Technical Service Bulletin: TSB180099

New Engine Oil Pressure Transducer

- K19

Figure 1, New Ground Wire and Transducer Installed.

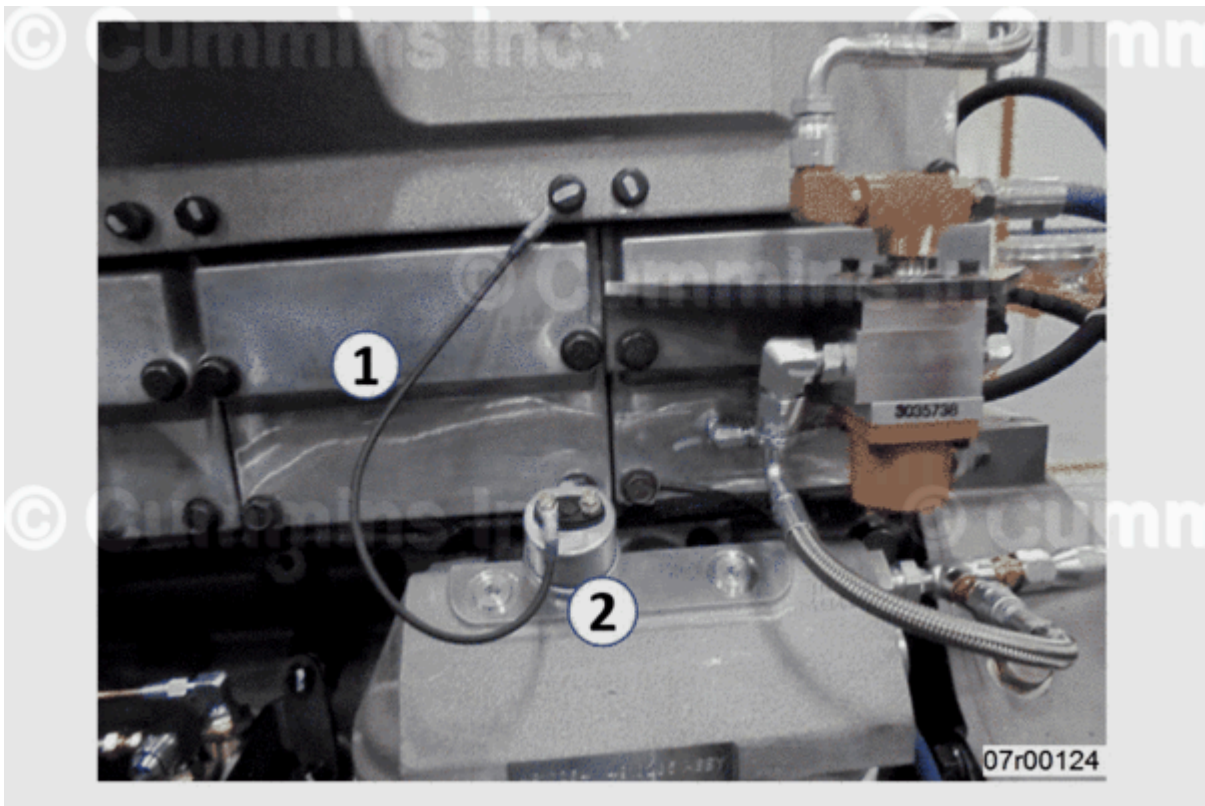
This document announces a oil pressure transducer, oil pressure gauge, adapter harness, and oil pressure transducer ground wire.

New adapter harness must be used when installing new oil pressure transducer and oil pressure gauge. See Table 1 below for part number information.

Ground wire **must** be attached to intake manifold as shown in Figure 1 or oil pressure transducer and oil pressure gauge will not function.

1. New ground wire, Part Number 5483521.
2. New oil pressure transducer, Part Number 3917123.
